STAFF RECOMMENDATION
1306 Edgewood Place
June 19, 2013

Application: Demolition-outbuilding; New construction-outbuilding
District: Lockeland Springs-East End Neighborhood Conservation Zoning Overlay
Council District: 06
Map and Parcel Number: 08305026200
Applicant: Preston Quirk, Architect
Project Lead: Sean Alexander, sean.alexander@nashville.gov

<p>Description of Project: The applicant is proposing to demolish an existing non-contributing outbuilding and construct a new outbuilding. The new building will have cement-fiber siding, a composite shingle roof, and an eighteen foot (18') wide vehicle door on the front elevation.</p> <p>Recommendation Summary: Staff recommends approval of the proposed new outbuilding with a condition that the double-door on the front of the garage is changed to two doors. Having met that condition staff finds that the application would meet the applicable sections on the Lockeland Springs-East End Neighborhood Conservation Zoning Overlay design guidelines.</p>	<p>Attachments A: Photographs B: Site Plan C: Elevations</p>
---	--

1306 Edgewood Place, rear yard.

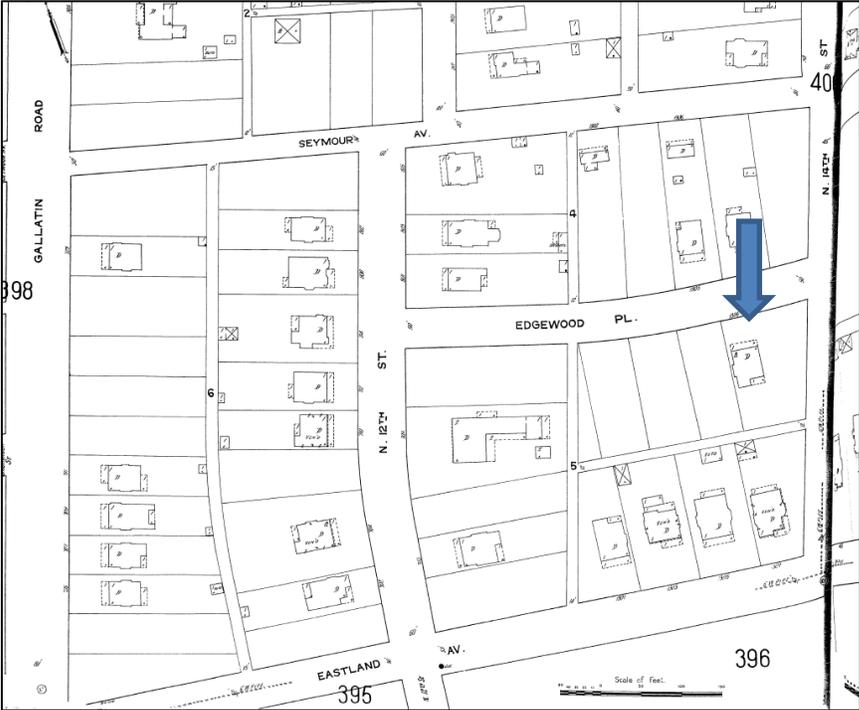
The existing outbuilding does not contribute to the historic character of the neighborhood. Demolition of the structure meets guideline IV.B.2.b.

1 GAR FRONT ELEVATION
SCALE: 1/8" = 1'-0"

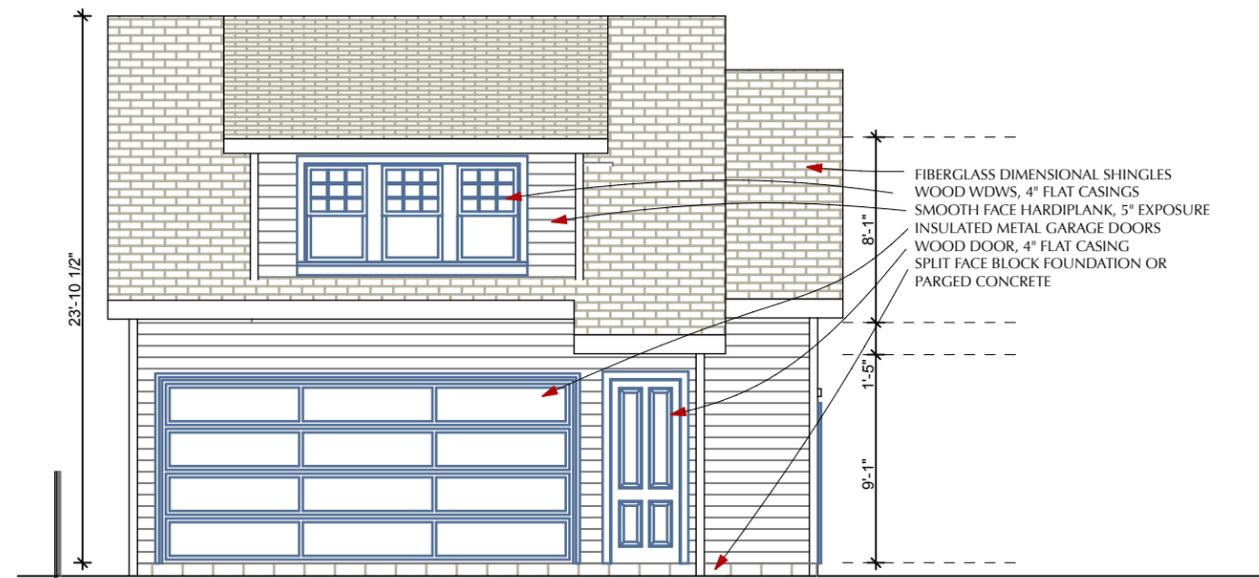
The windows and pedestrian door of the garage will be consistent with those found on historic accessory buildings, but the vehicle door will be an eighteen foot (18') wide double-door. This type of large opening is not compatible with the proportion of opening found on historic accessory buildings. In the past, the Commission has required two separate doors for two-bay garages where the vehicular opening faces the street. With a condition that the double-door is changed to two doors, staff finds that the proportion and rhythm of openings would meet guideline II.B.7.

Staff recommends approval of the proposed new outbuilding with a condition that the double-door on the garage is changed to two doors. Having met that condition, staff finds that the application would meet the applicable sections on the Lockeland Springs-East End Neighborhood Conservation Zoning Overlay design guidelines.
